**ADDENDUM NO. 2  
TO SPECIFICATIONS AND PLANS FOR THE  
VILLAGE OF GROSSE POINTE SHORES  
COOK ROAD PUMP STATION WATERPROOFING AND WEIR MODIFICATIONS**

**ISSUED:** July 20, 2026

HRC Job No. 20250315

WEIR WALL/ STOP LOG  
DETAILS AND NOTES

| DATE<br>July 2026       | SHEET NO.<br>S-3 OF |

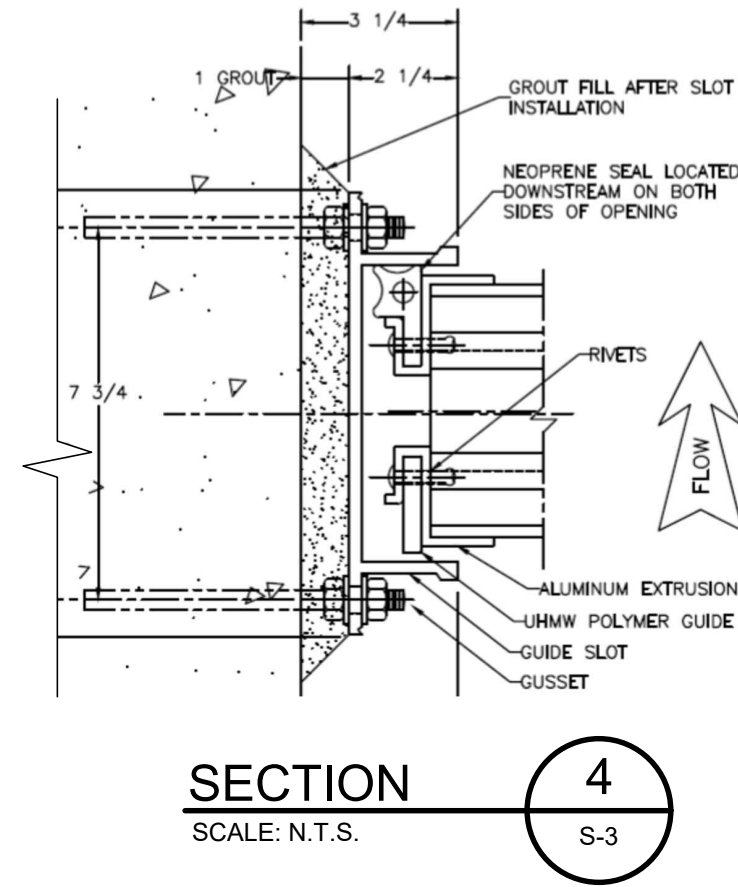
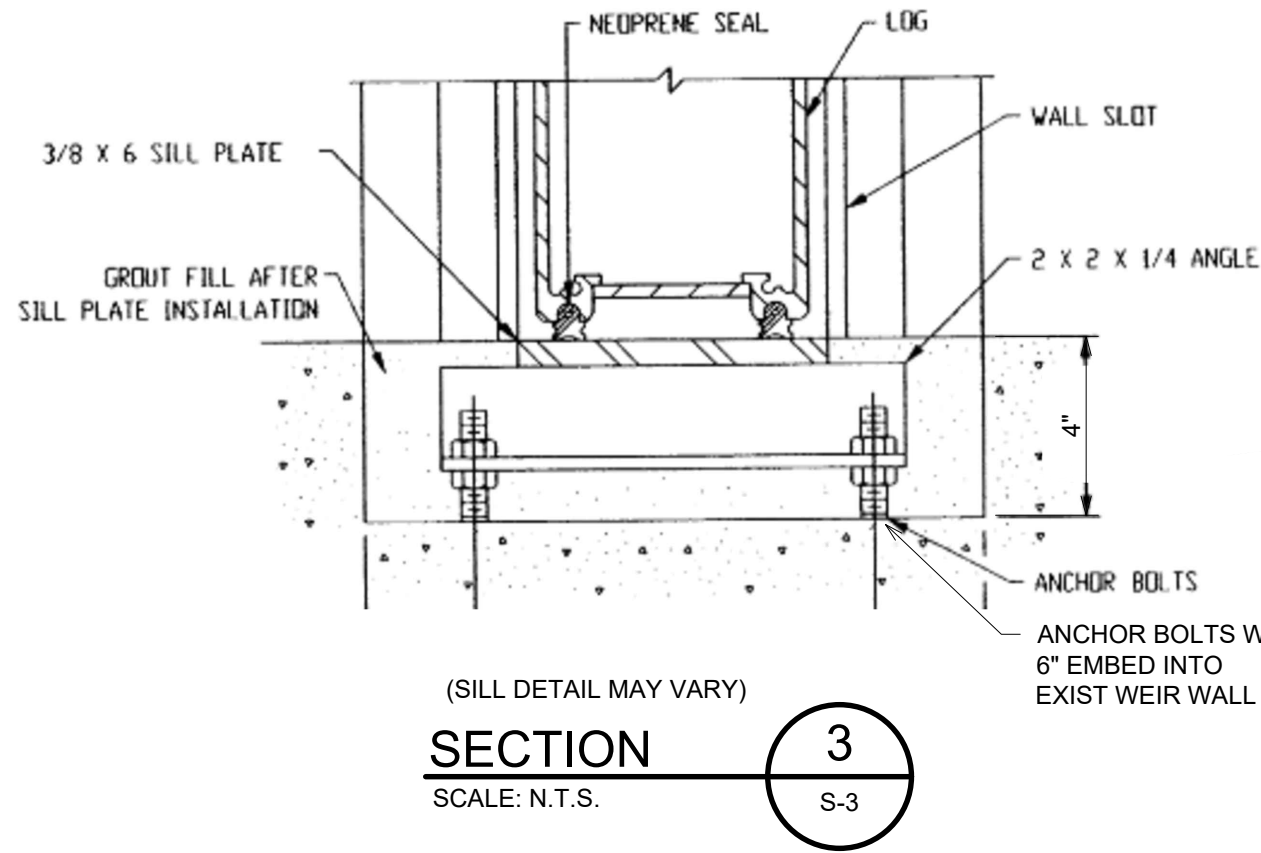
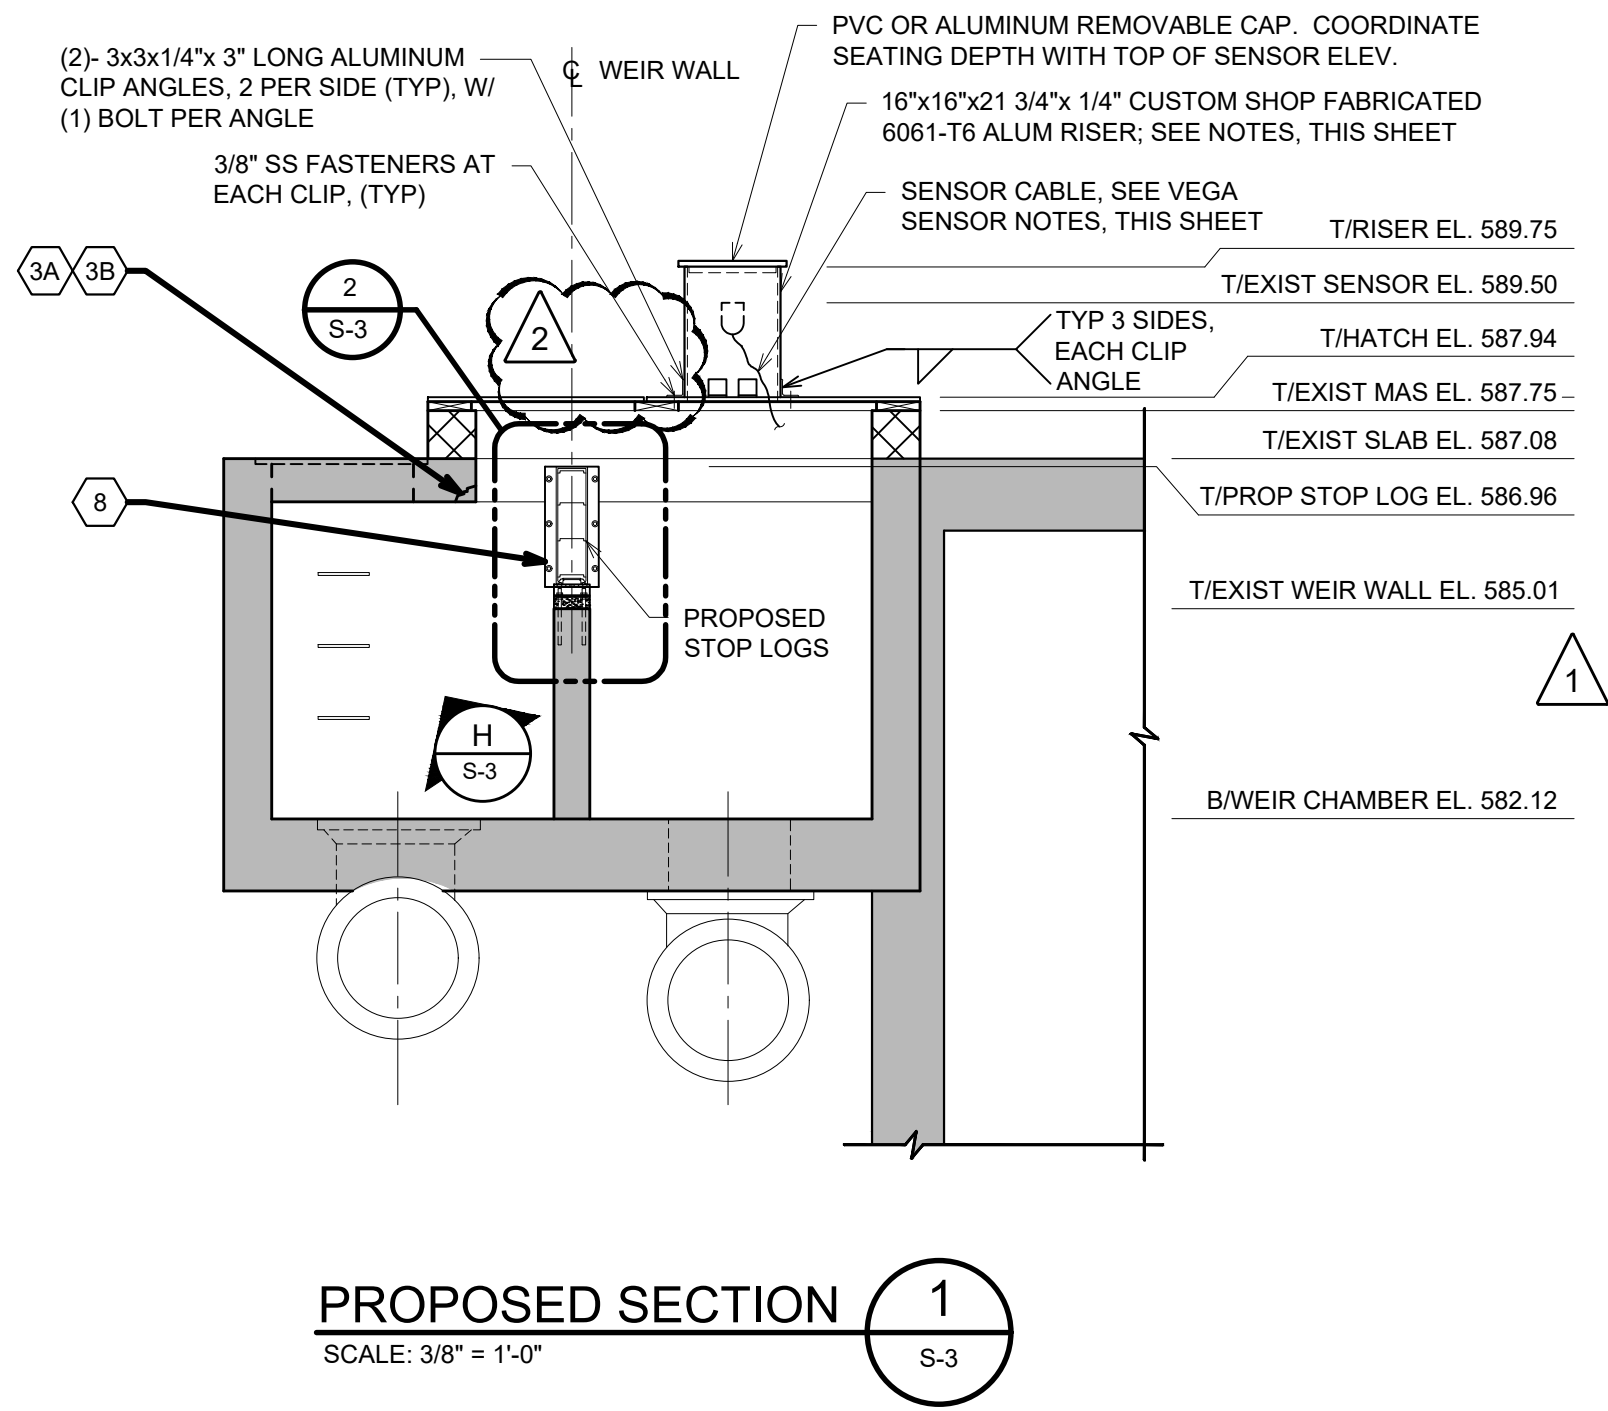
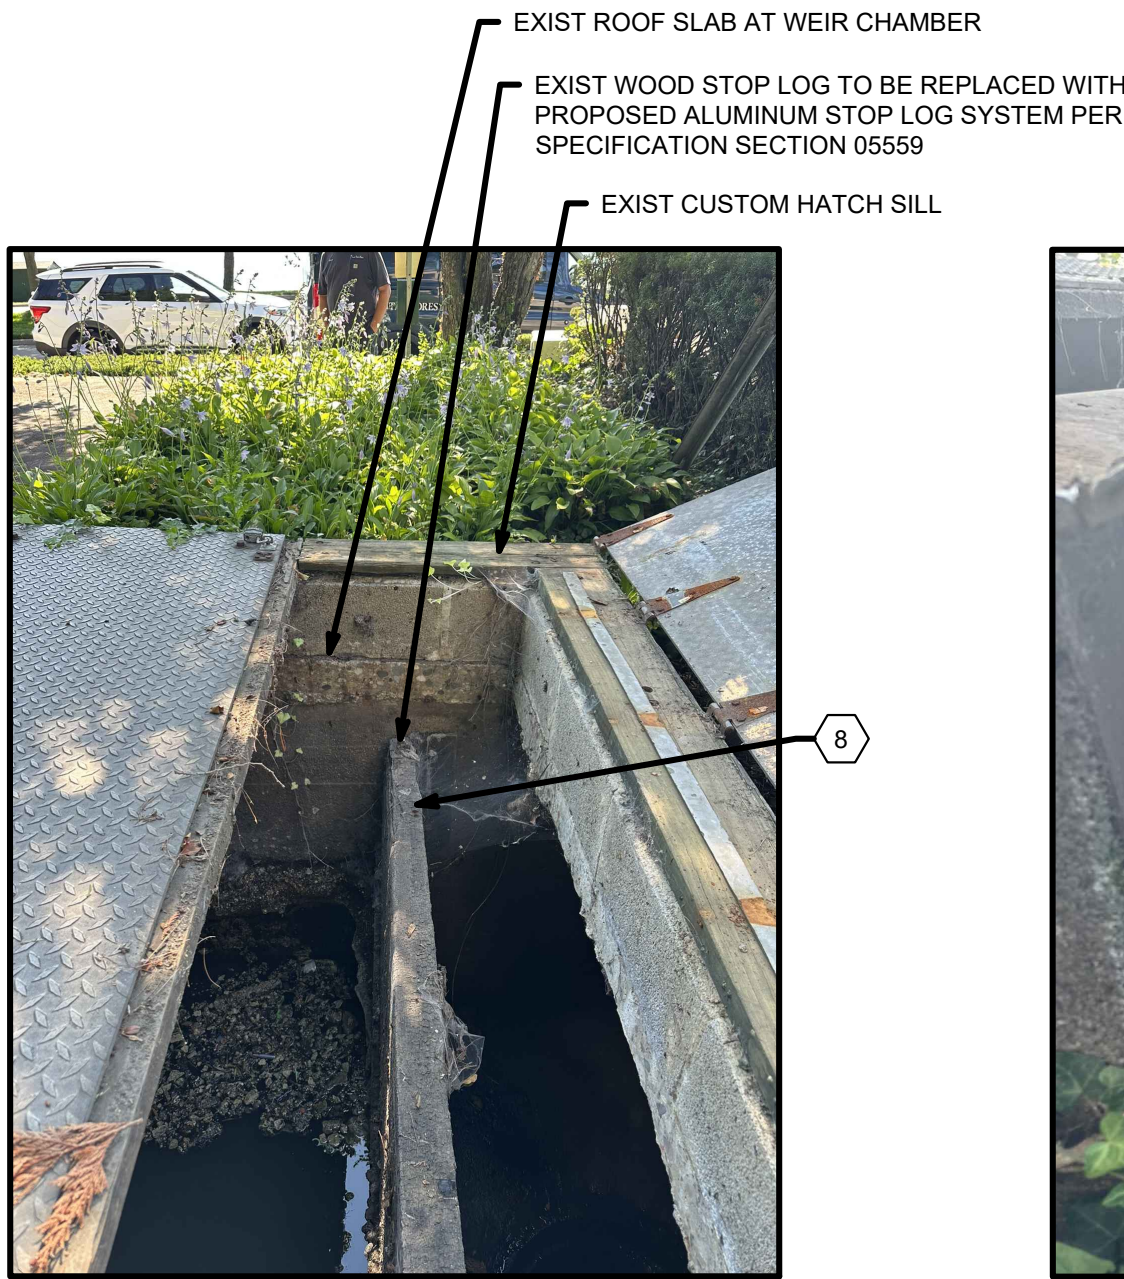
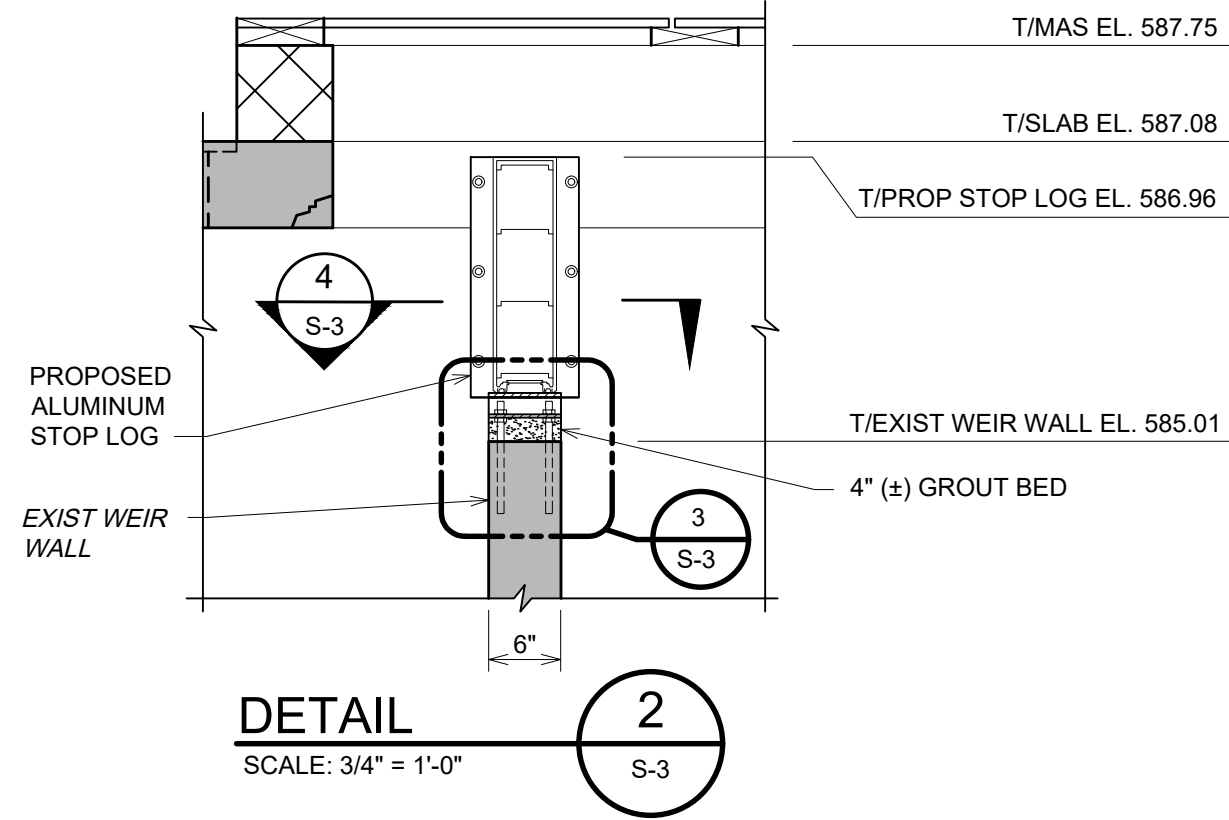
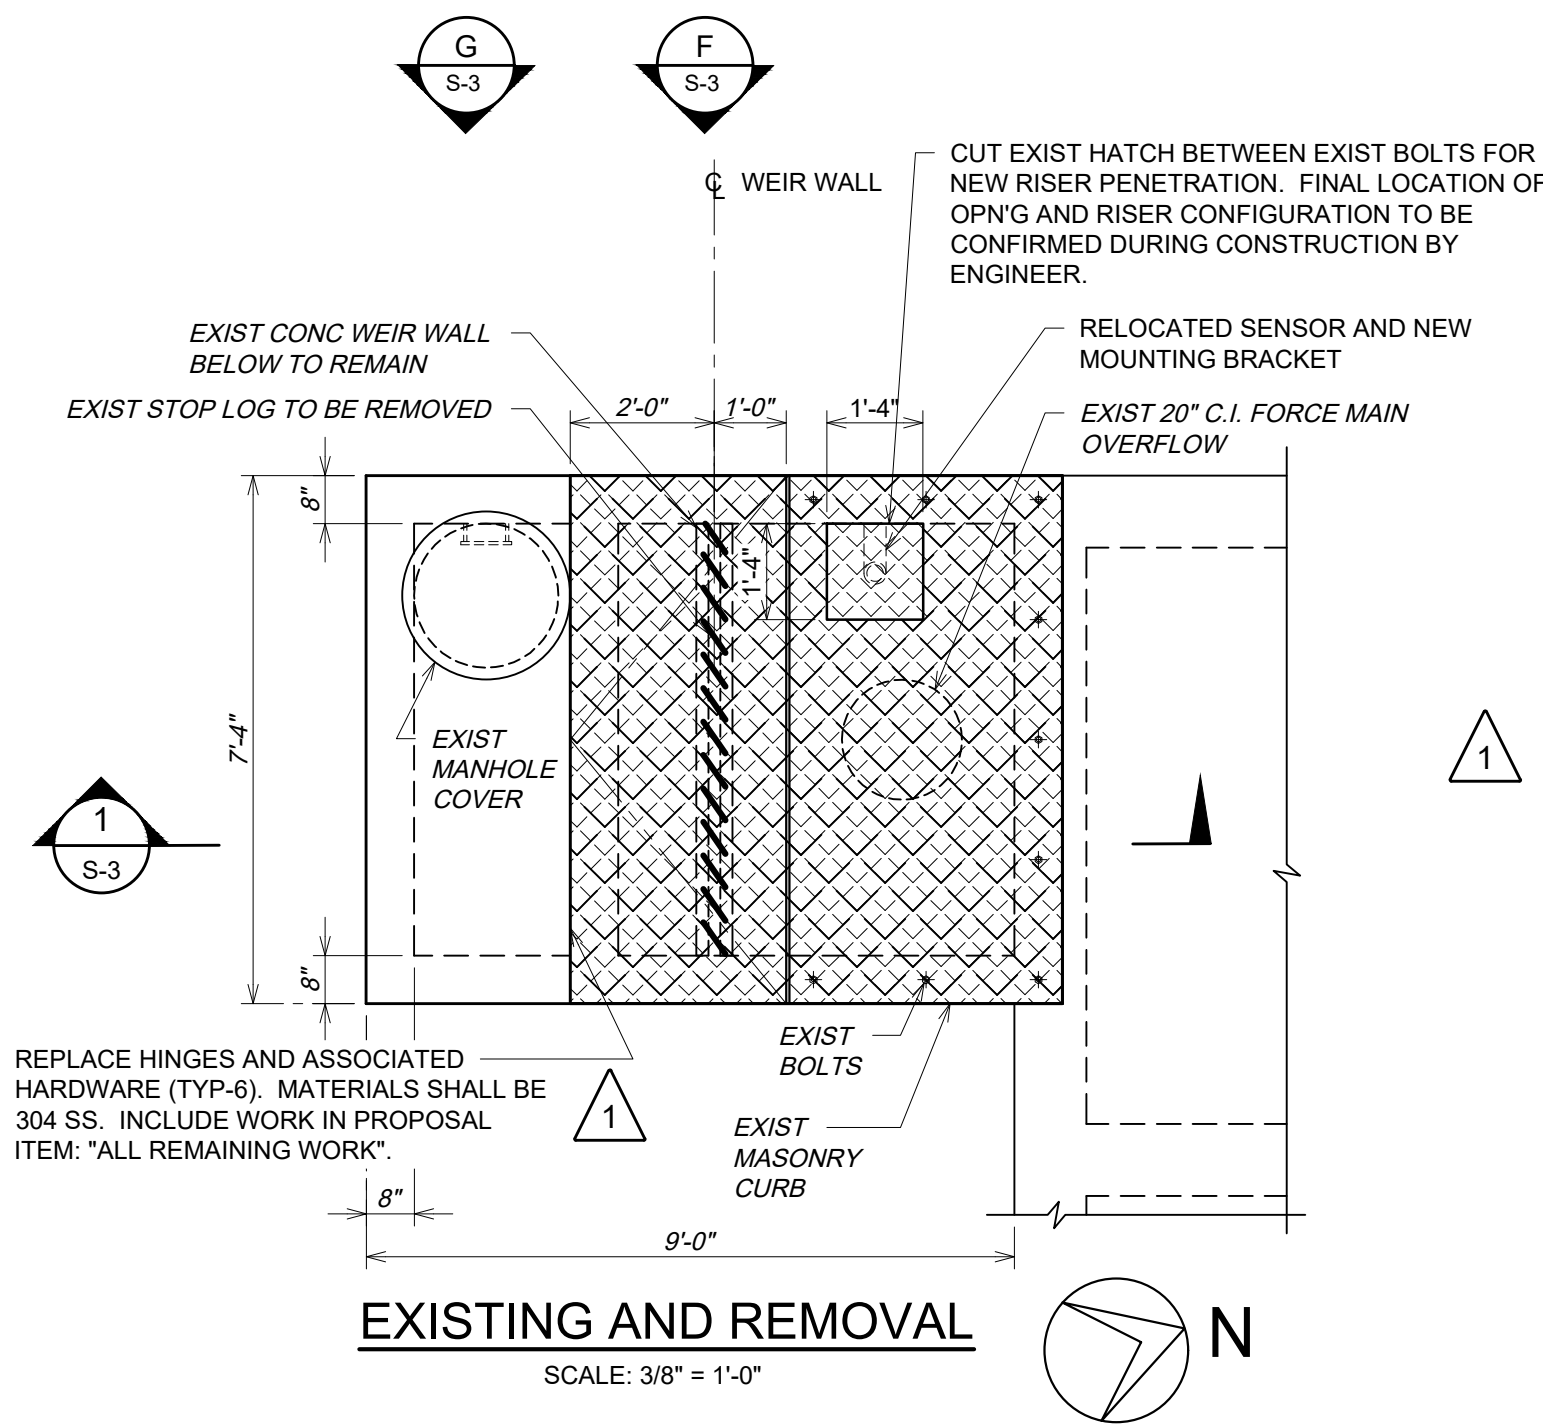
1. **DRAWING S-3 (ISSUED)**
  - a. Adjusted leaders in Proposed Section 1 and included the Relocate Vega Sensor proposal work item in the Repair Miscellaneous Quantities table.

- CONTRACTOR TO RELOCATE VEGA SENSOR WITHIN THE WEIR CHAMBER INTO RISER, MOUNTED OFF WEST SIDE OF RISER. SEE PROPOSED SECTION 1 THIS SHEET.
- MOUNT SENSOR IN CENTER OF PROPOSED 16"x16" ALUMINUM RISER USING NEW BRACKET AND HARDWARE. OBTAIN NEW BRACKET AND HARDWARE FROM VEGA.
- BOTTOM OF SENSOR ELEVATION SHALL BE 589.00 FEET.
- RUN CABLE INTO RISER. SLACK IN CABLE MUST BE ENOUGH TO ALLOW HATCH TO OPEN, AND AFFIXED OUT OF SENSOR PATH BY MOUNTING CABLE TO SIDE OF RISER AND UNDERSIDE OF HATCH.
